Re: DA344-11-2001-Mod-5 Request for Additional Information

Following receipt of the Department's request for additional information issued on 10/12/2025, and a meeting at the Department's Parramatta office on 20/1/2026, Walker Quarries (Walker) and Irwin Environmental Management (IEM) have reviewed our approach to defining the Previously Approved Disturbance Area (PADA) of the Wallerawang Quarry.

The PADA is central to the proposed modification which seeks to reclassify the biodiversity obligations and credits of DA 344-11-2001.

Revised PADA – DWG 1927_WQ_DR6

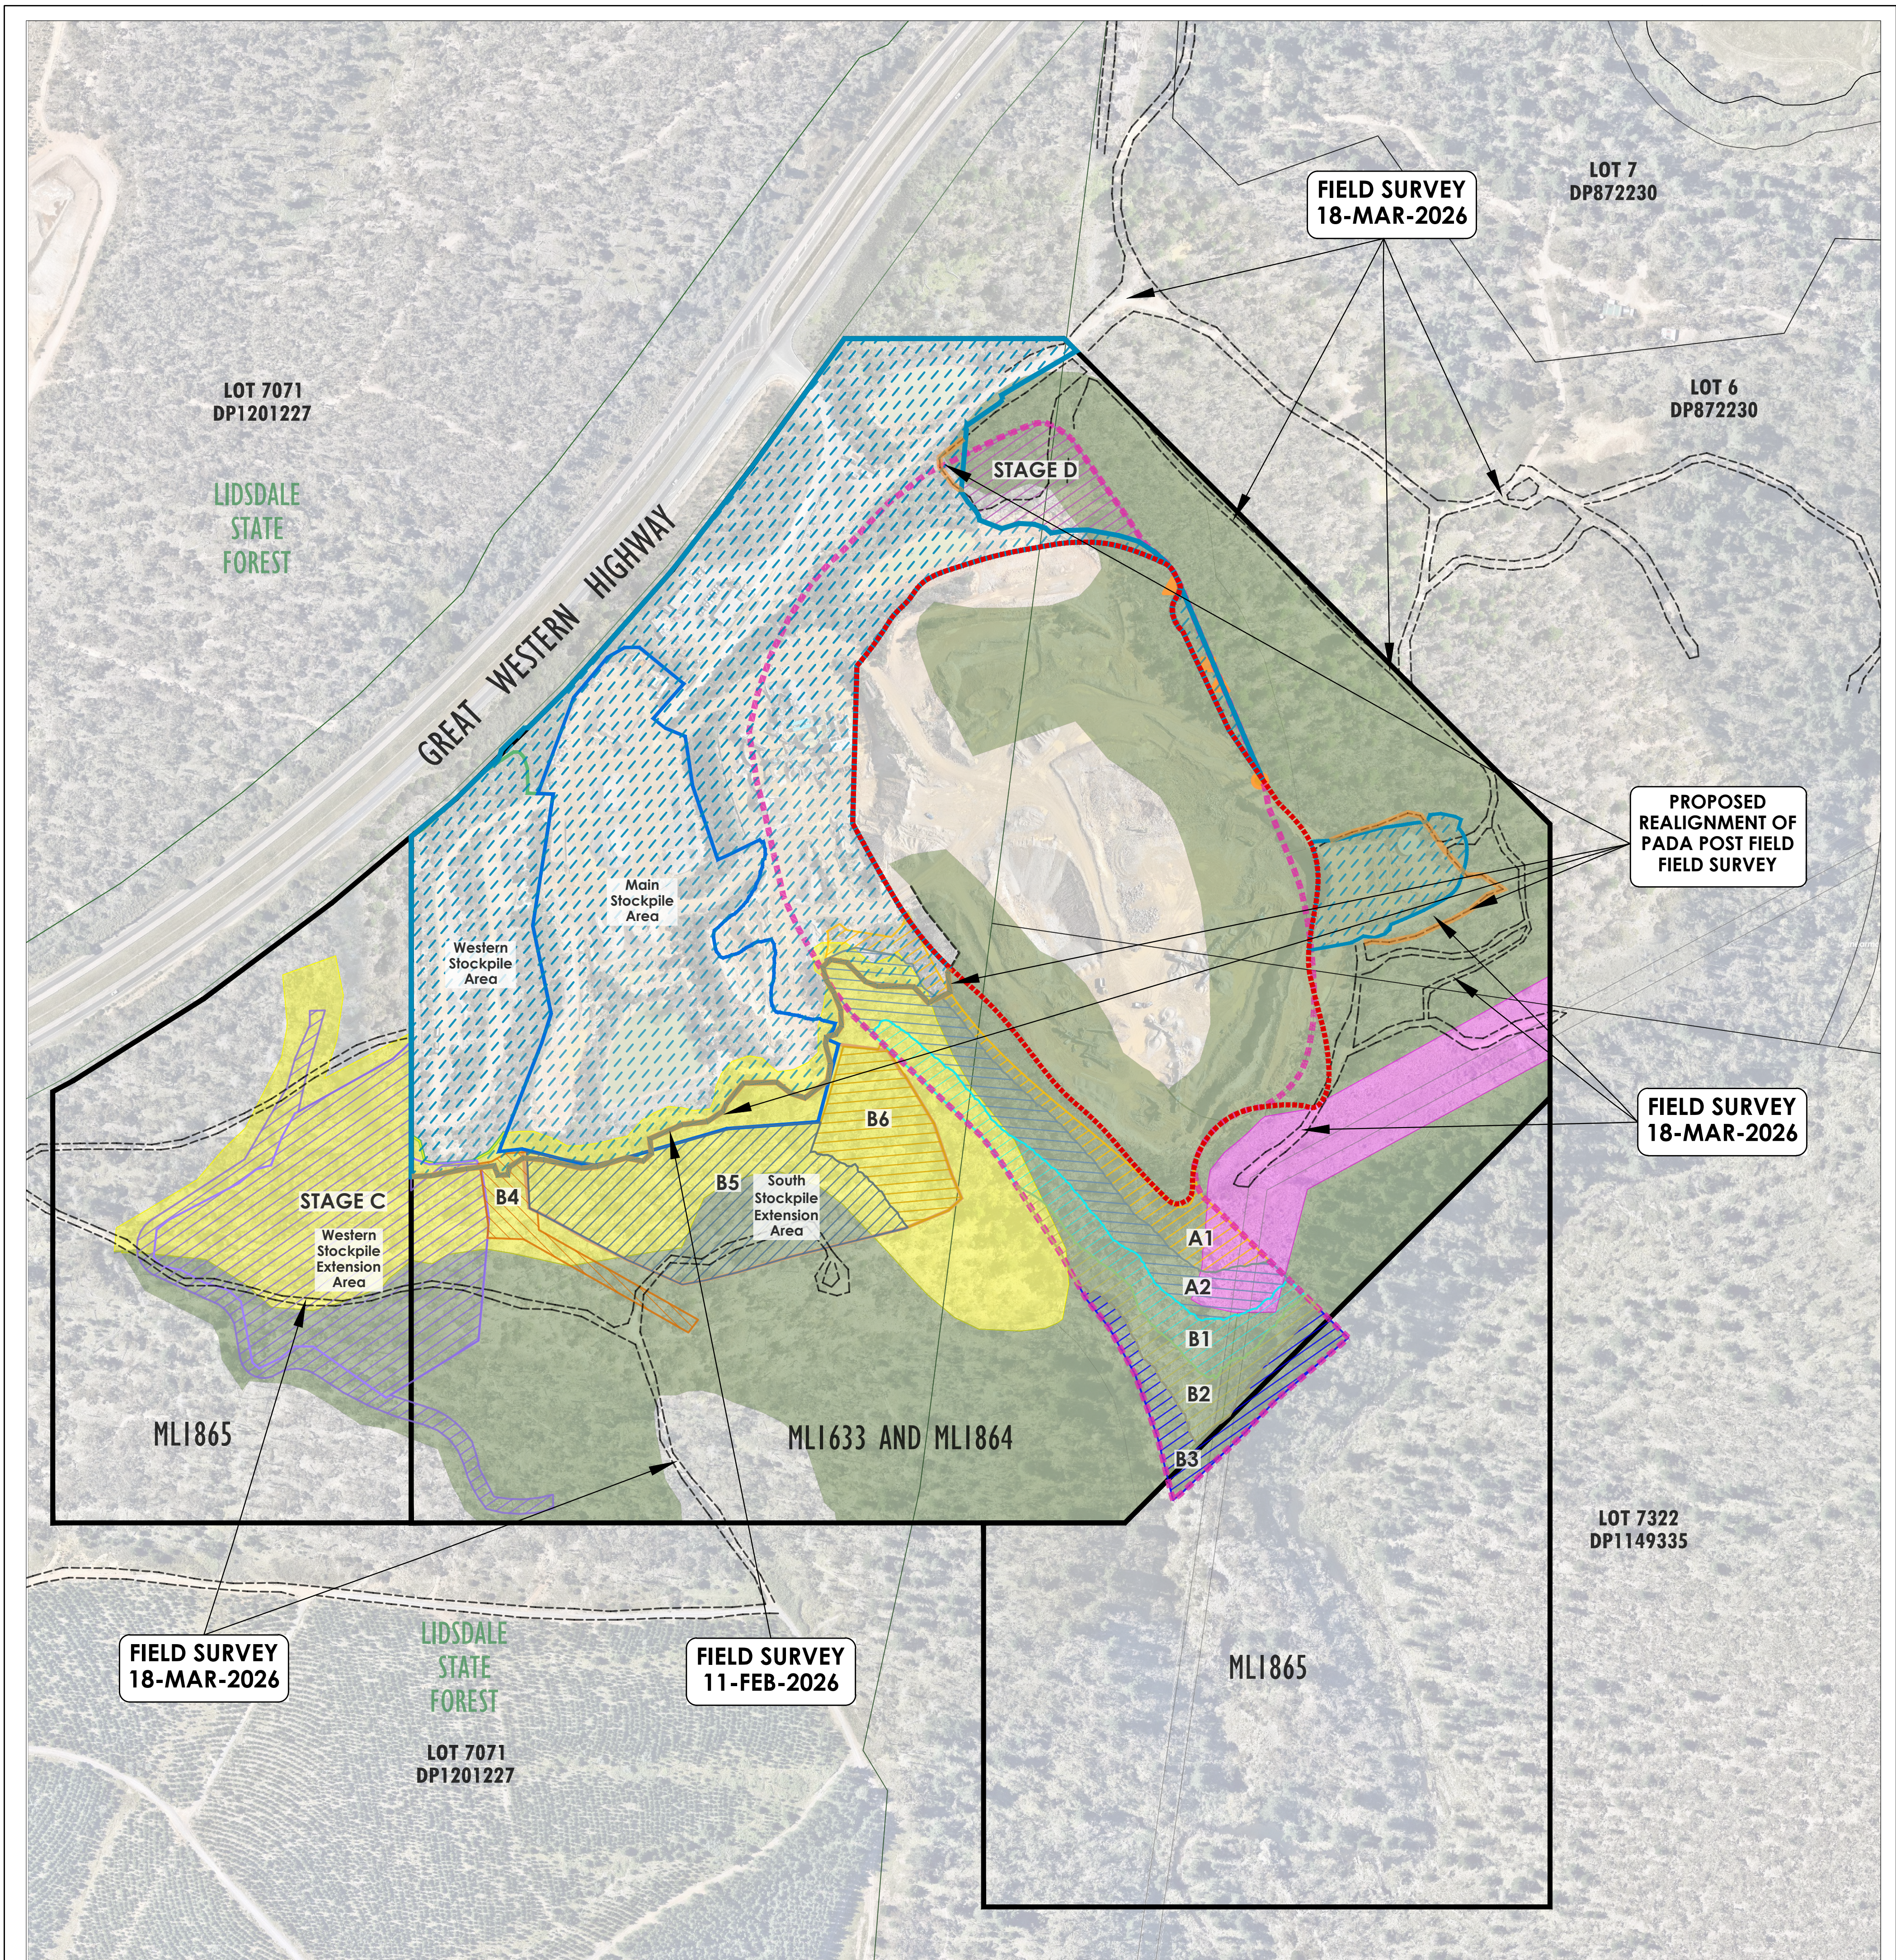
1. The PADA has been modified to better reflect the western perimeter of the extraction area as presented in the 2001 EIS.
2. The PADA has been modified to better reflect the southern perimeter of the extraction area as presented in the 2001 EIS.
3. With reference to *Figure 3.7* of the 2001 EIS, a small discrepancy between the eastern perimeter of the 2001 EIS extraction area and that presented in subsequent modifications has been identified.

4. *Figure 3.7* of the 2001 EIS includes a slight 'bulge' in the extraction area. This has been included in the modified PADA.
5. The field survey of 11 February 2026 has been relied upon to define the limit of disturbance associated with the Main Stockpile Area (as of May 2017 and regularised by MOD 1). The PADA and Offset Stages have been revised to reflect this survey line.
6. The field survey of 18 March 2026, which follows the perimeter of disturbance of the Eastern Stockpile Area and roads (confirmed as present in May 2017 through analysis of aerial photos), has been relied upon to define the limit of disturbance of the Eastern Stockpile Area (as of May 2017 and regularised by MOD 1).

The field survey identified a small discrepancy in the extent of disturbance near SB2 resulting in a small reduction to the PADA and slight modification to Offset Stage D.

7. Having accepted *Figure 3.7* of the 2001 EIS represents a defined limit of disturbance¹, a reduction in the PADA to match this between the Eastern Stockpile Area, extraction area and roads providing access to the Powerline staunions has been applied.

As this area was accounted for by the regularised extraction area of MOD 1, confirmed by in-field survey markers identified by the 11 February 2026 field survey (refer to Attachment B), it remains within the PADA.

The PADA has been revised to reflect this survey.

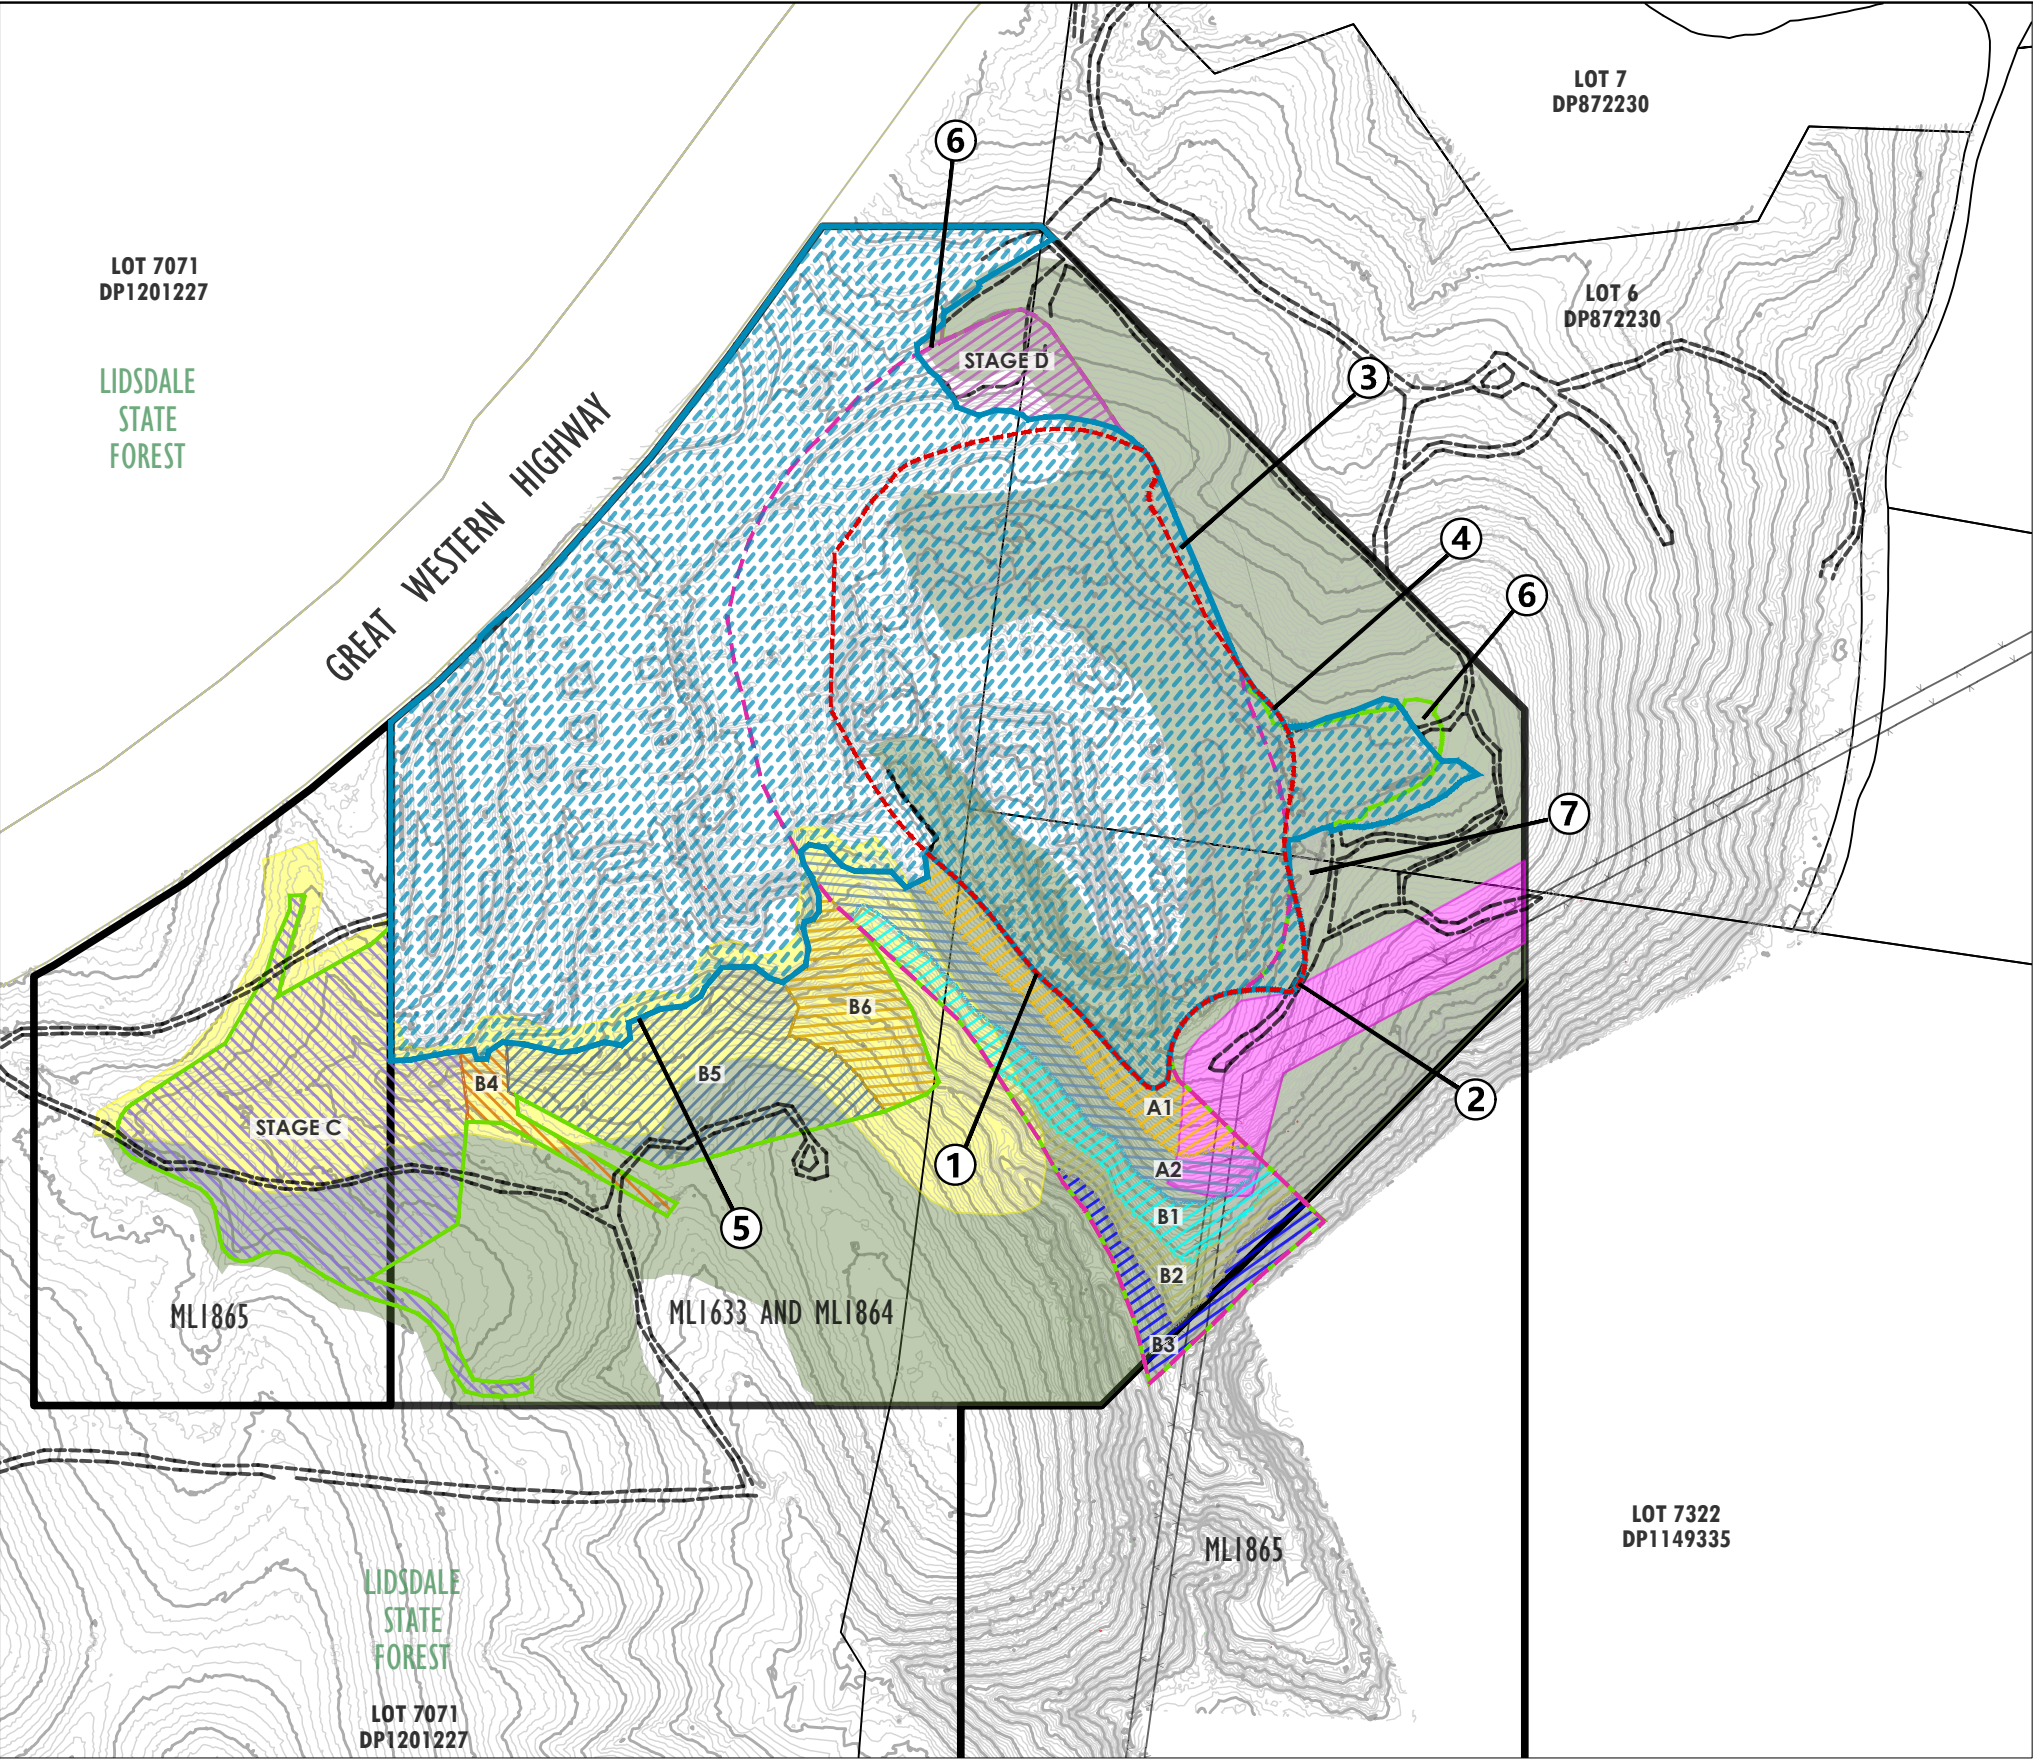
- 3.7. **Attachment B** includes a drawing created by CEH Surveyors (Plan 1927_WQ_DISTLIMIT) which overlays the stockpile areas, extent of native vegetation mapping (from the 2019 BDAR) and modified offset stages (for MOD 4).

- 3.8. In nominating the PADA presented for MOD 4, AREA Environmental & Heritage Consultants Pty Ltd (AREA) excluded the areas of mapped native vegetation occurring within the polygons identified as Approved Disturbance on *Figure 2.2A*, i.e. the areas identified by red arrows on the figure on p.7.

- 3.13. Notably, the field survey closely (but not exactly) aligns with the mapping used by EcoPlanning in the 2019 BDAR to calculate biodiversity offsets (refer to **Attachment B**).

- 3.14. The field survey has now been used to define the southern boundary of the PADA (refer to **Attachment B**).
- 3.15. As a result of the re-surveyed and redrawn boundary of the Modification 1, minor adjustment to the PADA and offset areas B4, B5 and B6 are required.

The shape and orientation of the approved Eastern Stockpile Area has also been further scrutinised. It is evident from historic aerial imagery that the boundary used to define the limit of the Eastern Stockpile Area does not accurately reflect the extent of this feature dating back to MOD 1 (May 2017).

- 3.16. Field survey completed by Trenten Hudson of CEH Surveyors on 18 March 2026 has mapped the extents of this disturbance. On the basis that MOD 1 regularised the site as per May 2017 (the date of application), Walker Quarries presents the surveyed disturbance boundary as the true extent of the PADA.
- 3.17. Minor adjustments to the PADA (including a reduction where the previous mapping included areas of undisturbed vegetation within the Eastern Stockpile Area) have subsequently been made and are identified in **Attachment B**.
